Manchester and High Peak Area

Oldham Group

Re: The Transport and Works Act 1992 - The Transport and Works (Applications and Objections Procedure) (England and Wales) Rules 2006.

1.2 In this letter of objection I am referring "to the proposal empowered by Article 19 and set out in Part 2 of Schedule 8 to the draft Order, namely the extinguishment of footpath 209 SADD between P1 and P2 (depicted on sheet 15)."

Photo 244.10d – Approaching Oldham Road and private rear gardens. Nobody was around on my visit.

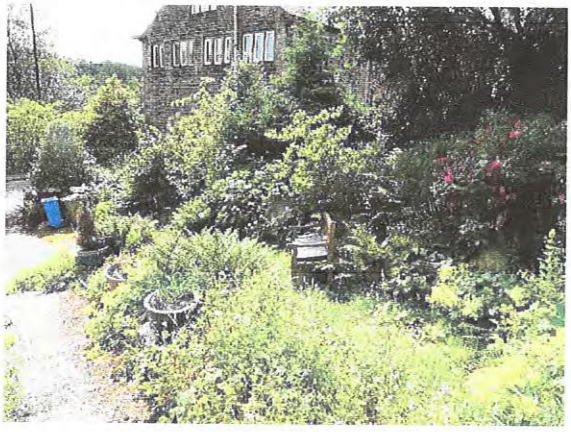
Photo 244.11d – Number 8 on the right with a seat. If the numbers of 46 walkers per day then the privacy of the owners would be compromised.

Photo 244.12d – Number 6 on the left. The comment above is the same.

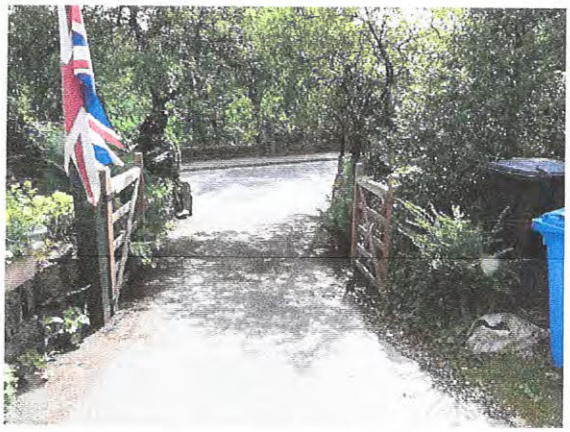
Photo 7.5.13 – Approaching Oldham Road. Gates open but if closed would put walkers off due to the perceived privacy.

Photo 7.5.14 – Minimal footway looking towards the canal and Uppermill about 100m away. The distance between the white stone and the kerb is 450mm.

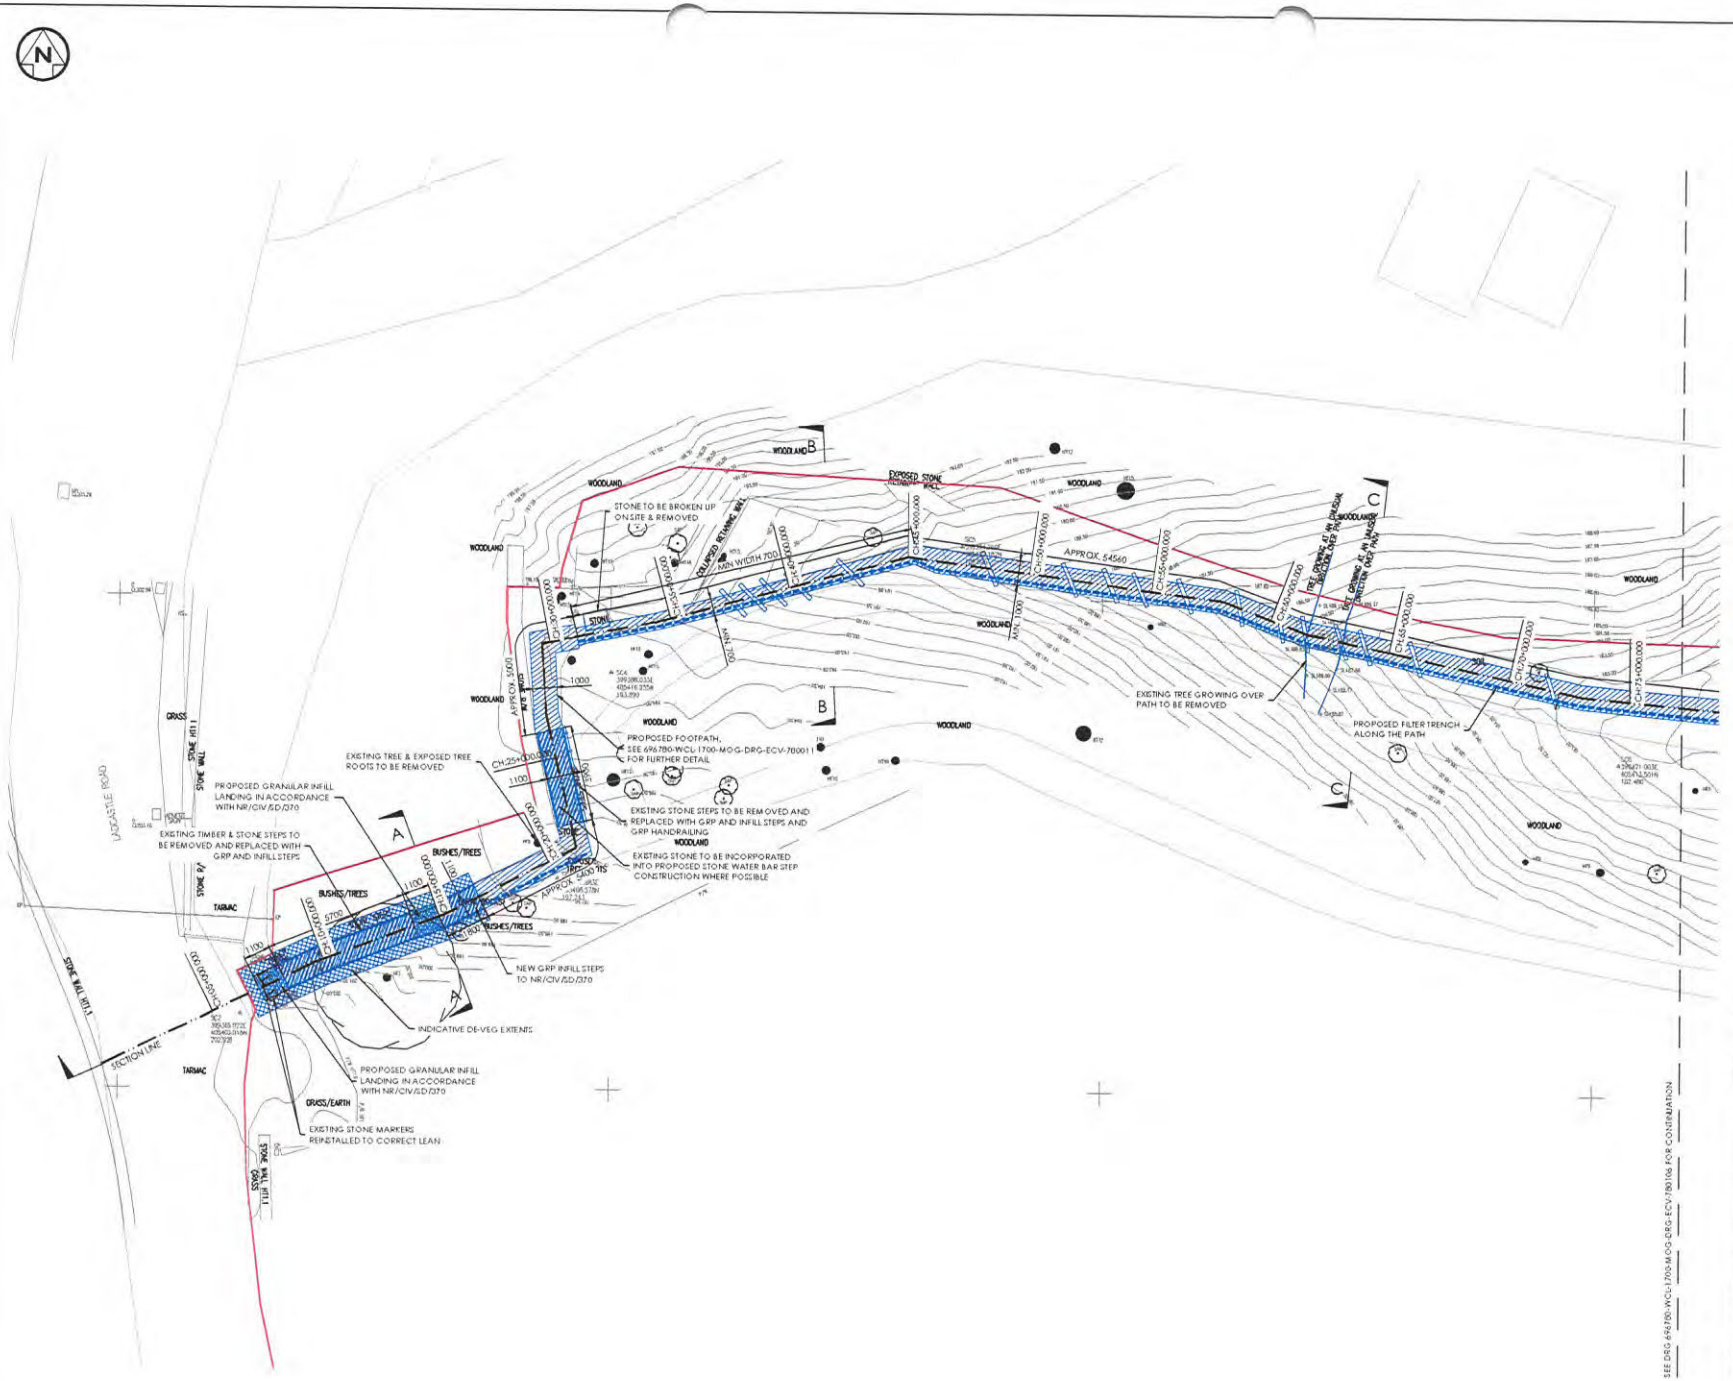
8.15 Footways and footpaths should be made as wide as is practicable, but under normal circumstances, a width of **2000mm** is the minimum that should be provided, as this allows enough space for two wheelchair users to pass, even if they are using larger electric mobility scooters. *If this is not feasible due to physical constraints, then a minimum width of **1500mm** could be regarded as the minimum acceptable under most circumstances, as this should enable a wheelchair user and a walker to pass each other.* My italics. **See Appendix 8.1**

8.16 Unfortunately there is no "single" minimum footway width, but rather a hierarchy of widths to design to. The minimum widths are set out in inclusive mobility. Please note that this document is guidance, not regulation. The widths are design widths for new footways and should held as a standard for existing footways.

8.17 Most existing footways are 6ft wide (~1.8m) as this was the width of two 3ft flags and therefore do not meet the 2m minimum specified.

Photo 1 – Bus approaching the bottom of path 244

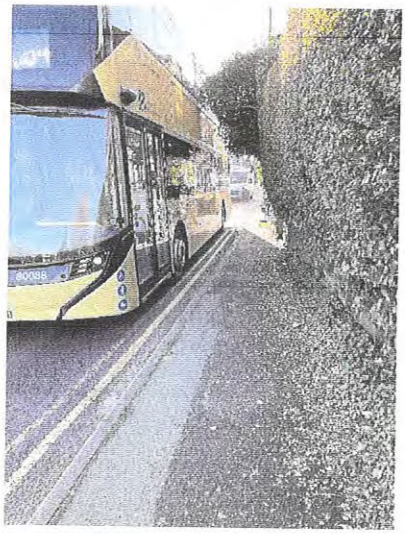
Photo 2 – Bus at the bottom of path 244 where the pavement is 450/600 but it widens out towards the camera

Photo 3 - Even large cars are close to the pavement. You can see the small boundary stone which is 450 from the edge of the pavement.
